Detroit  
Edison

August 13, 1992  
NRC-92-0095

Subject: Detroit Edison Response to NRC Plant System Branch (SPLB) Verbal Request for Additional Information on Fermi 2 Power Uprate Submittal (TAC No. 82102)

Subject: Responses to NRC Plant System Branch (SPLB) request for  
Additional Information on Fermi-2 Power Uprate

CONT. OF SPINCE  
RECTIC BRK

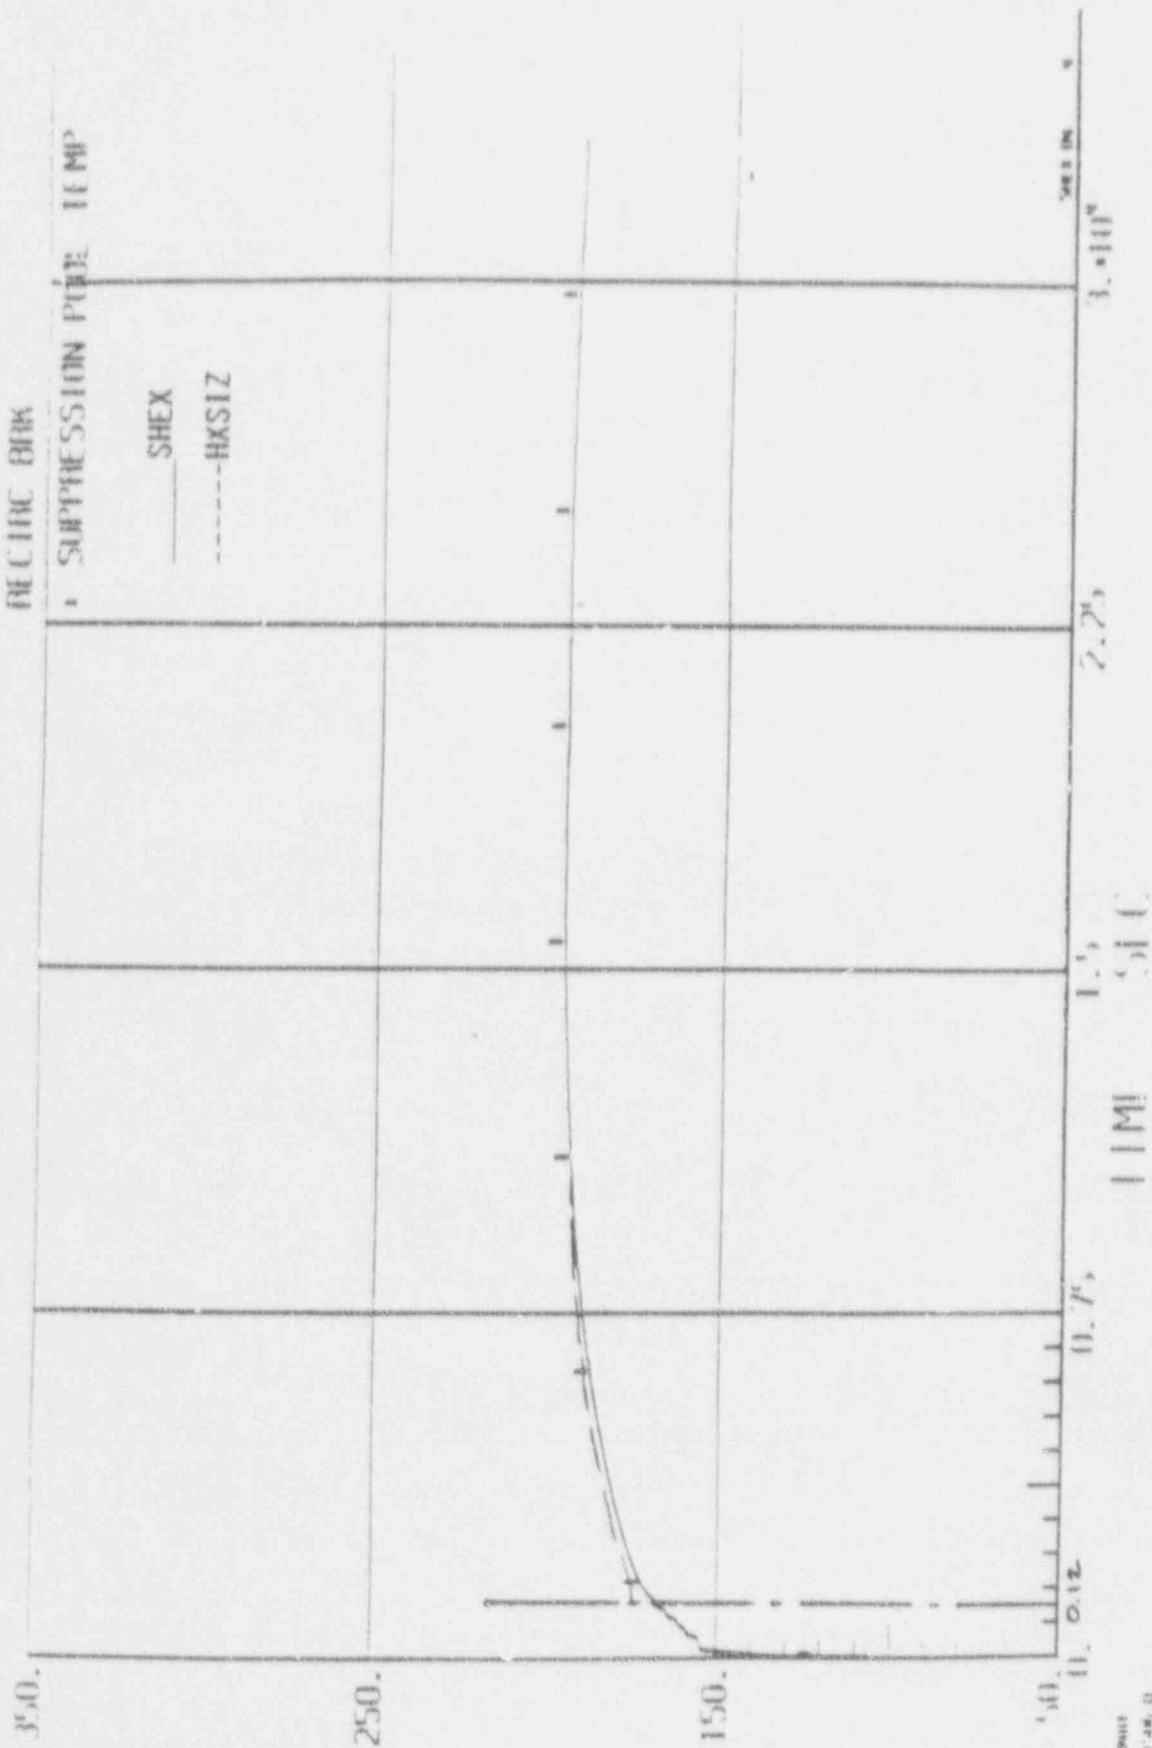
Document the one to one comparison performed between SHEX and HXSIZ performed for the December 1991 meeting. Also, discuss the bases for concluding that HXSIZ was (probably) the code used during the original licensing of Fermi-2.

A comparison of the M3CPT/HXSIZ method and the SHEX code was performed. The important inputs, as presented in Table 3, are identical. The M3CPT/HXSIZ analysis was performed using Power Uprate initial conditions. This was done because the uprated power is the condition of most interest for this comparison. The results of the comparison would also be applicable at a lower power level.

The results of the analysis show that SHEX gives a peak suppression pool temperature of 196.5°F. The M3CPT/HXSIZ codes give a peak suppression pool temperature of 196.1°F. These results are shown in the attached figure. The difference is considered negligible, showing that SHEX is an acceptable alternative to M3CPT/HXSIZ for analyzing the long-term suppression pool temperature response.
